UNITED STATES OF AMERICA
NUCLEAR REGULATORY COMMISSION
BEFORE THE SECRETARY

Callaway Plant Unit 2

Docket No. 52-037

REPLY OF MCE/MSE

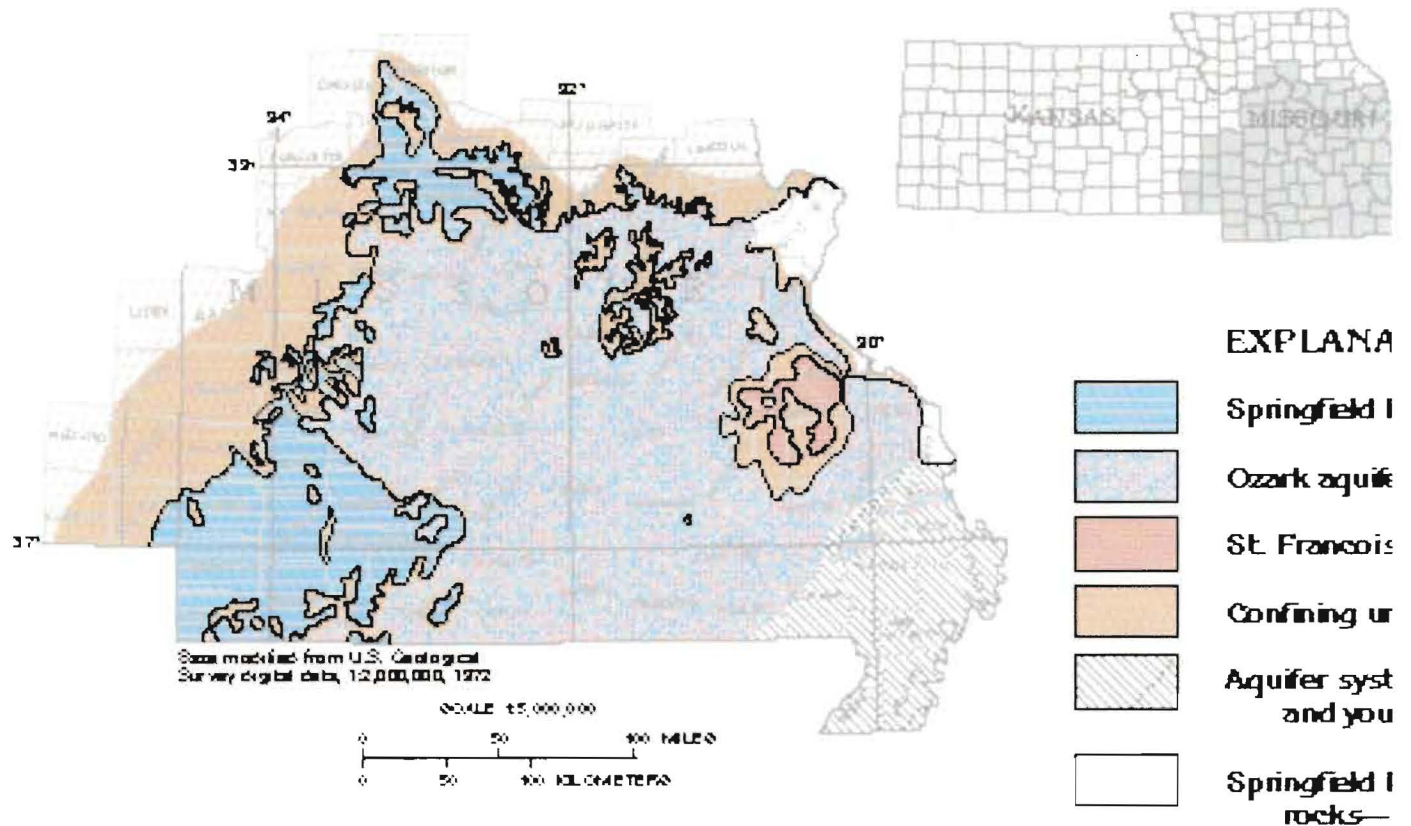
In fact, the authorities cited by UE actually confirm Criss's statements while refuting UE's own, not only regarding a name commonly applied to these water-bearing strata, but more importantly concerning UE's description of the actual hydrogeologic character of the strata included within the CJC formations, which directly bear on UE's analysis of pumping impacts. For example, USGS (1997, p. D20) clearly states that “The Ozark and the Cambrian-Ordovician aquifers are mapped together in this report” and that they are “equivalent,” refuting the answer's claim at p. 40 that this same authority “differentiated” these aquifers in the report. More importantly, UE insists that the upper half of the CJC unit is an “aquitard” (e.g., ER 2-60; Fig. 2.3-21), that these same strata are “confined” and “artesian” (ER 2.3 page 2-54; Answer pp. 34–35), and that the CJC aquifer is regionally considered to represent “the top of the Cambrian-Ordovician aquifer system” (ER 2.3 pp. 2-61, 2-89). To the contrary, authority considers the entire CJC formation to be part of a thick hydrostratigraphic aquifer, regardless of whether the CJC strata occur south or north of the river, and regardless of whether the collective unit may be called the Ozark aquifer to the south or the Cambrian-Ordovician aquifer to the north of the Missouri River (see Imes, 1985, 1988; USGS 1997). Specifically, Fig 95 of the *Groundwater*

Atlas of the United States (USGS 1997, Hydrologic Atlas 730-D), which is attached to this reply as an exhibit, shows that a 5–10 mile wide region mapped as the “Ozark Aquifer” occurs throughout all of southern Callaway County, to the NORTH of the Missouri River, in a zone encompassing all of the area south of the power block, including all of the area spanned by the UE computer model, and all of the groundwater users along CR 457 mentioned in the Criss declaration. In direct contrast to UE’s characterization, no “confining beds” are shown in this zone; those are mapped only to the north of the power block (see Fig 95 of USGS 1997).

Thus, published authority that is inconsistently and incorrectly cited by UE (Answer, p. 40) directly refutes UE’s characterization of the fundamental hydrogeologic nature of the relevant aquifers in the project area. Criss’s point is therefore not one of semantic detail as alleged by the answer, and even were this true he would have abundant support (USGS 1997, Fig 95), but rather he has raised a material issue, and his declaration provides a clear-cut documentation of UE’s persistent mischaracterization of the hydrogeologic character of the CJC strata, which are the exact same strata that provide essential drinking water to private and public wells near the site (Table 2.3-30), and the strata that would be affected by the huge pumping increases anticipated by UE. As Criss also clearly states, mischaracterization of the hydrologic properties of those water-bearing strata will directly affect the outcome of the UE computer model, directly refuting UE’s claim (Answer p. 31) that this matter is not contested.
